UNITED STATES
DEPARTMENT OF THE INTERIOR
BUREAU OF LAND MANAGEMENT

FORM APPROVED
OM B No. 1004-0137
Expires: March 31, 2007**SUNDRY NOTICES AND REPORTS ON WELLS**
*Do not use this form for proposals to drill or to re-enter an
abandoned well Use Form 3160-3 (APD) for such proposals*
SUBMIT IN TRIPLICATE - Other instructions on reverse side.

Apache Corporation proposes to P&A the above mentioned well by the attached procedure.

Empire Abo Unit "I"

PROPOSED PROCEDURE

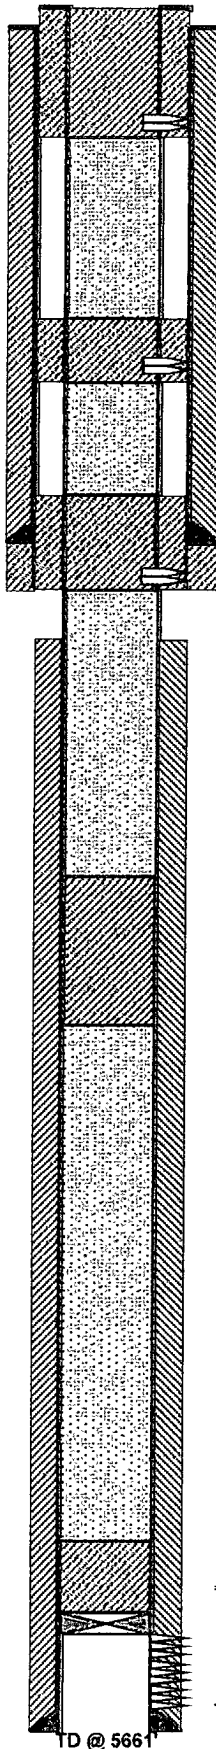
5. PUH & perf @ 940' & sqz 50 sx Class "C" cmt from 940'-700' (Top of Queen) *WOC Tag (Perfs)*

4. PUH & perf @ 1668' & sqz 100 sx Class "C" cmt from 1668'-1400' WOC/TAG (Top of San Andres & Shoe)

3. PUH & spot 25 sx Class "C" cmt from 3055' to 2693' WOC/TAG (Top of Glorieta) *Tag Not Required*
